Technical Service Bulletin: TSB180087

New Junction Box

- NH, NT / PT Fixed Time
- NTA855

Figure 1, Old Box Junction Width – 89mm [3.5 in]

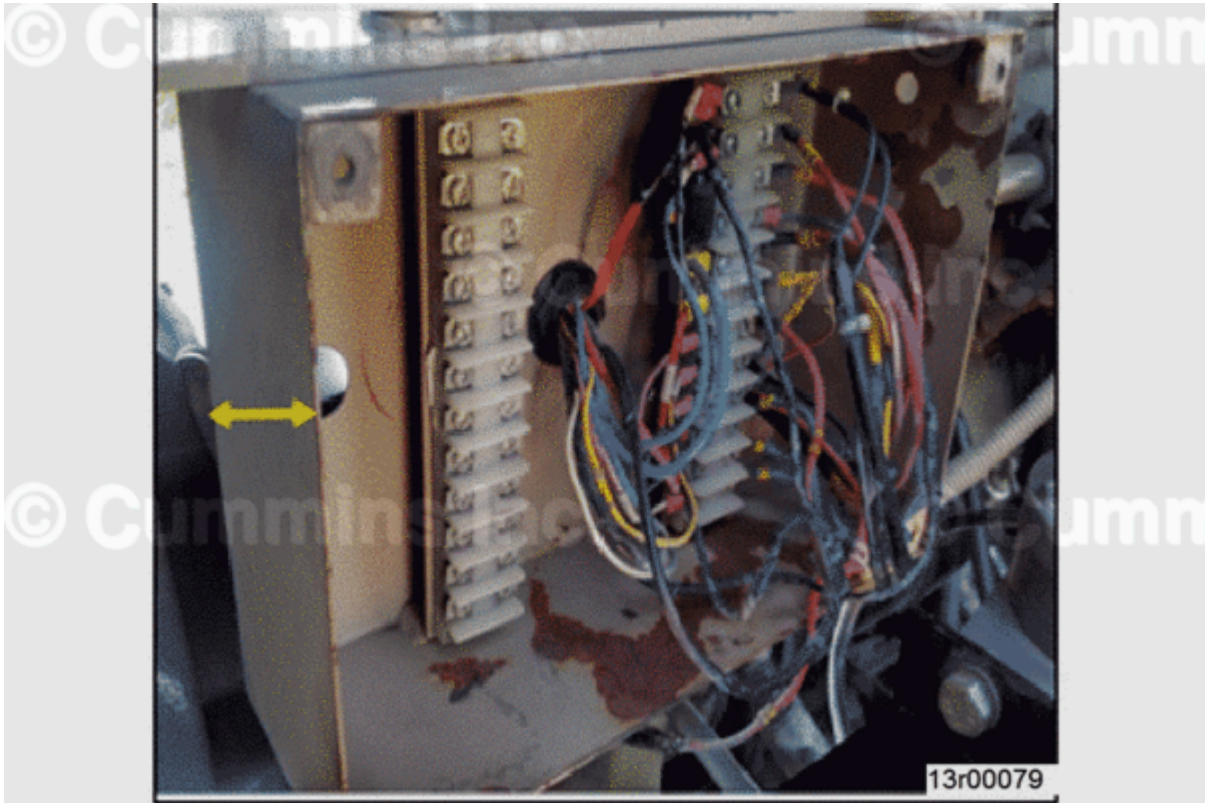
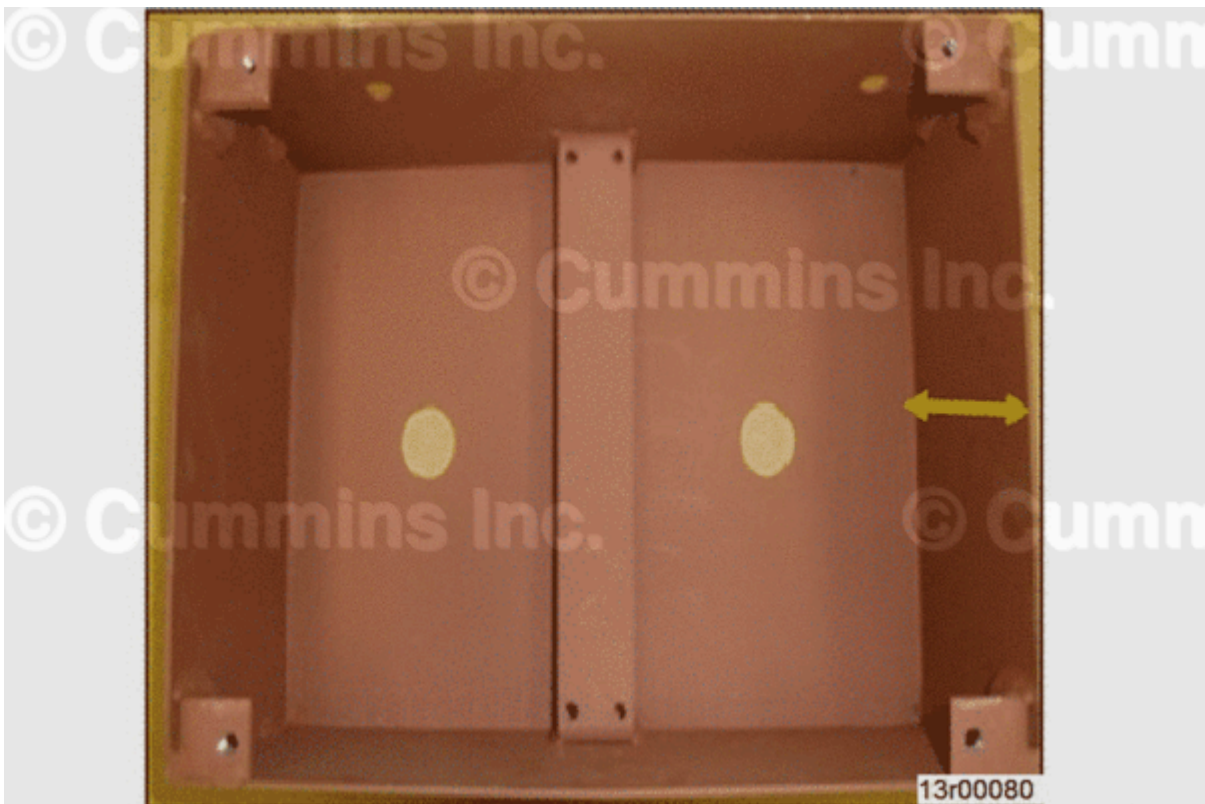
Wire insulation can malfunction because of contact with junction box front cover plate. This can lead to electrical system shorting and other component damage.

- Width increased by 30mm [1.18 in] for clearance between harness and front cover plate.
- Addition of 12mm +/- 1 mm [0.5 in] thick plain foam (Firend TB 070) on inside of front cover plate, with self-adhesive backing.
